Council Reference: DA10/0222.26 LN44549
Your Reference: MP06_0258 MOD 10

Comments on the proposed modification - amendment to Casuarina Town Centre including 56 lot subdivision, road works, infrastructure works and landscaping (Department of Planning Application MP06_0258) MOD 10 at Lot 13 DP 1014470; Casuarina Way CASUARINA; Lot 144 DP 1030322 & Lot 144 DP 1030322 & Lot 3 DP 1042119; Tweed Coast Road CASUARINA

Approved 20m Easement

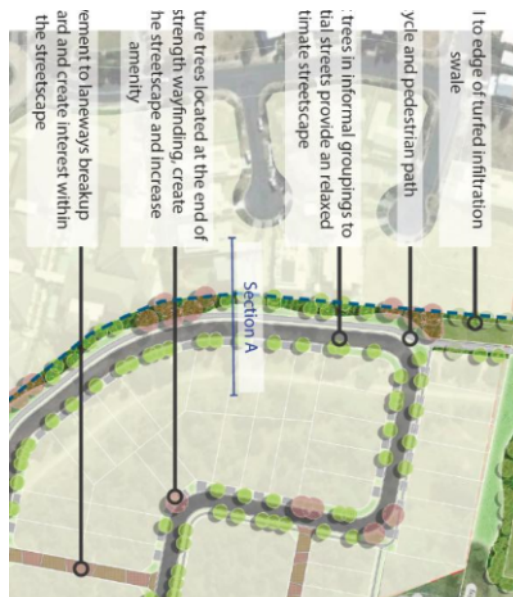
The submitted application outlines that the purpose of the swale was twofold, firstly to provide for stormwater management within Casuarina, and secondly to address the proposed land use interface with the adjoining northern residential dwellings.

Beyond this it is also noted that this easement is benefitted to Tweed Shire Council, and as such an application to extinguish same would need to be approved by Council.

Concept drawing of proposed 8m wide buffer

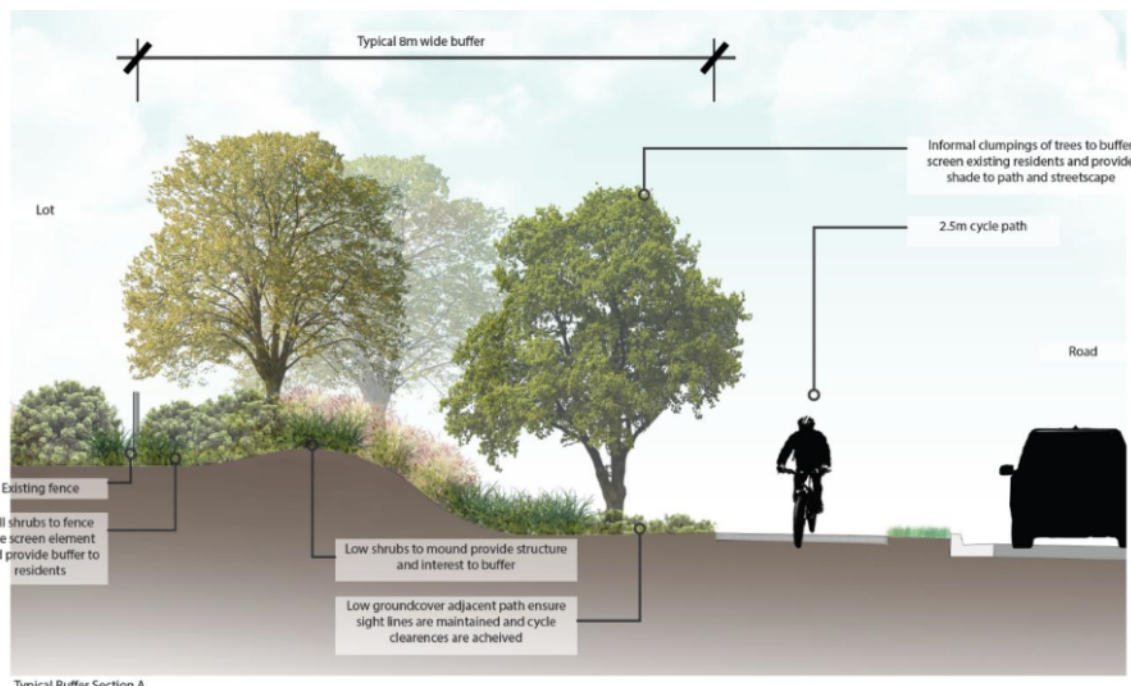
The proposed modification to amend this swale to the north site boundary has been reviewed by Council's Manager Roads and Stormwater (proposal would require changes to the easements benefitting Council), Development Engineer and Stormwater Engineer, with the following comments provided;

The drainage swale provides a high capacity connection between the coastal swale that services the Casuarina Estate and an outlet to Cudgen Creek to the west. It provides a high degree of infiltration due to the sandy soil. Taking into account the design specifications provided by the existing consent and Council's D5 specification, the modification application proposes to replace the open swale with large diameter pipes (3 x 1650mm pipes) to cater for the Q100 flow. Modelling demonstrates that this piped configuration does not increase upstream flood levels in extreme events, or increase the incidence of the coastal swale overtopping the dune to the beach. This would allow for the overall easement width to be reduced, provided equivalent infiltration can be achieved elsewhere in the trunk drainage system. As such, there is no hydraulic reason to oppose the piping of the swale drain, only the public benefits afforded by the wider easement.

Detail of the proposed configuration of the area within the easement is difficult to locate in the modification application. It is assumed that the area will be dedicated as a widened road reserve, containing landscaped vegetation for the first 8m from the northern boundary, a 2.5m wide cycleway, and then a local access street, up to the front boundary of low density residential allotments. The 3x1650 stormwater pipes, a

It is requested that the applicant provide a clear cross section showing all above and below ground infrastructure, landforming batters and retaining structures, and clearances between the various uses e.g. Vegetation, cycleway, roadway, verge widths, and piped infrastructure. Without such detail, it is suspected that inadequate width has been allowed for in the design, noting that approved 20m wide drainage reserve in the current approval did not include road infrastructure.

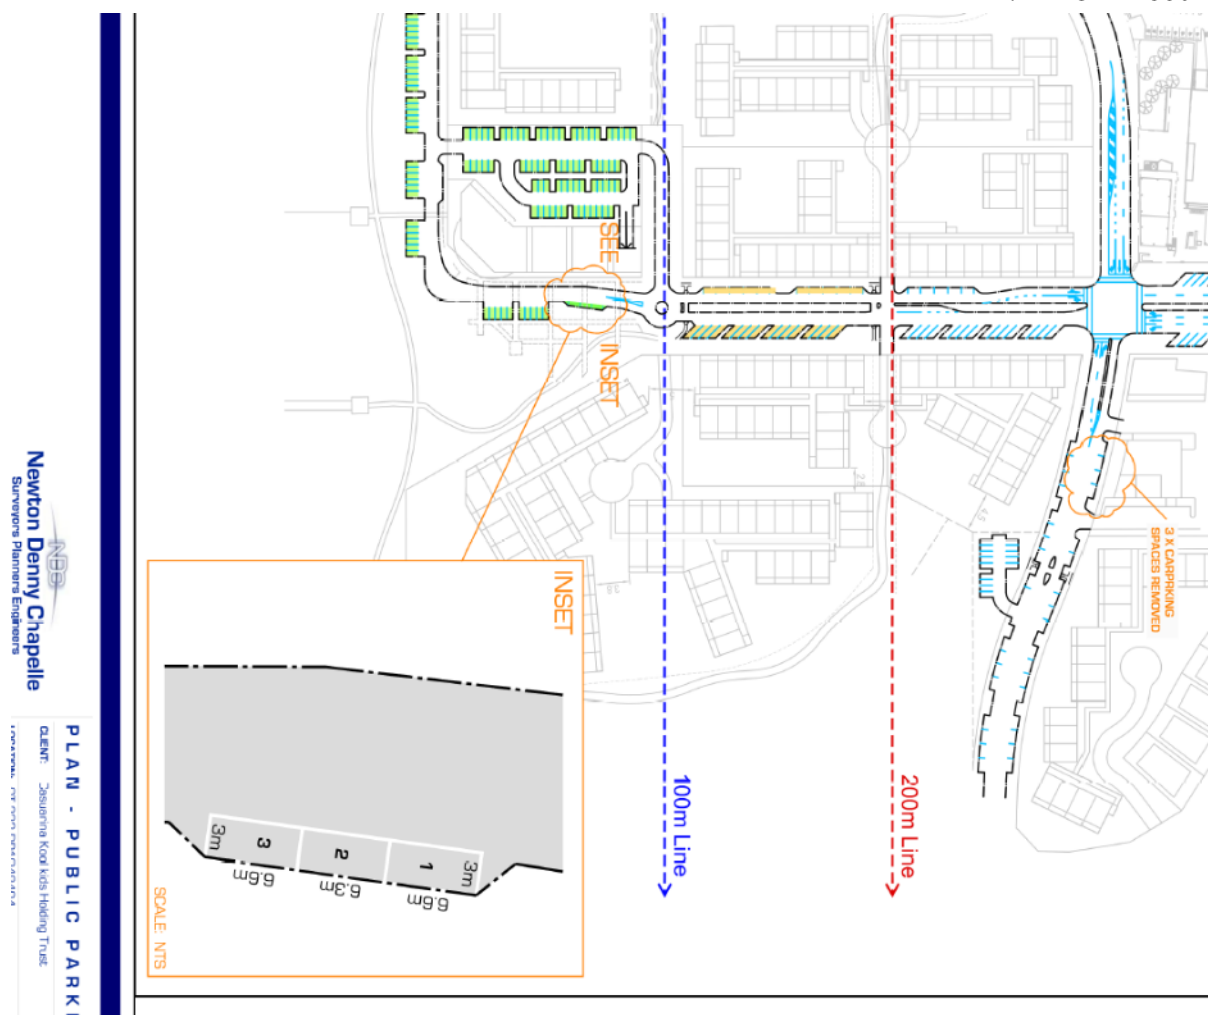
- The existing approval includes a proposed 3.5m wide cycleway connecting from Casuarina Way to Casuarina foreshore along an easement of various widths. In addition the approval provides an additional cycleway connection to Casuarina Way near the existing Santi building.

The proposed modification now seeks to reduce the proposed cycleway width from 3.5m to 2.5m and delete the additional cycleway connection to Casuarina Way near the existing Santi building. The cycleway width of 3.5m and cycleway connection to Casuarina Way near the existing Santi building is to remain as per approved.

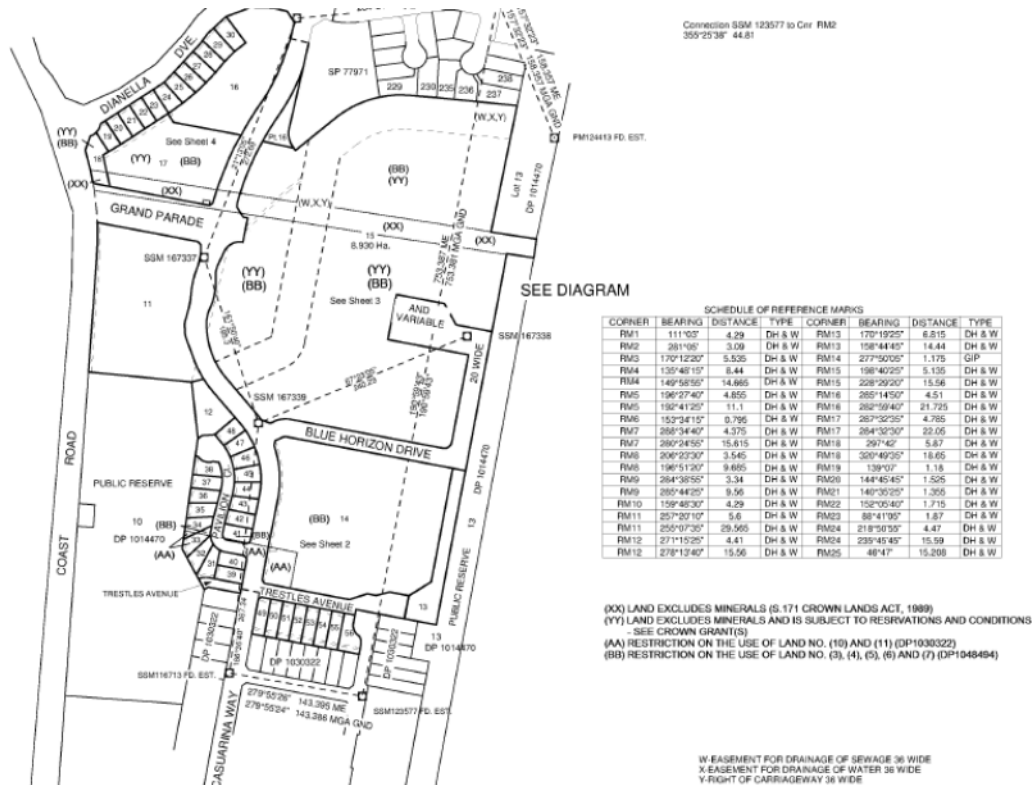
The current proposal does not acknowledge this previous advice, or attempt to address the urban design issues associated with the proposed changes to the easement and associated works. As such, there is no justification for Council to change the viewpoint of opposing piping of the whole swale, and no changes to the existing easement benefiting Council will be supported.
